# Technical Bulletin

**Tiptronic Transmission Fluid Level**

**Number**  
9504

**Models Affected:** **911 Carrera 2 1990-1994**

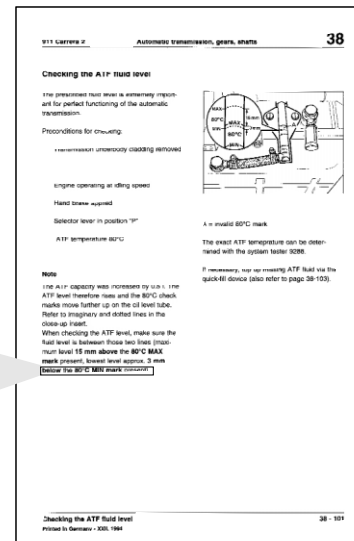
**Concern:** The Porsche Workshop Manual 911 Carrera 2/Carrera 4, Volume III, page 38-101 of supplement XXII, in the second paragraph under "Note" should read "**below the 80°C MAX mark present**". This information will be entered in a future supplement. Please write this change into the Workshop Manual on the above mentioned page.

below the 80°C ~~MIN~~ mark present).  
**MAX**
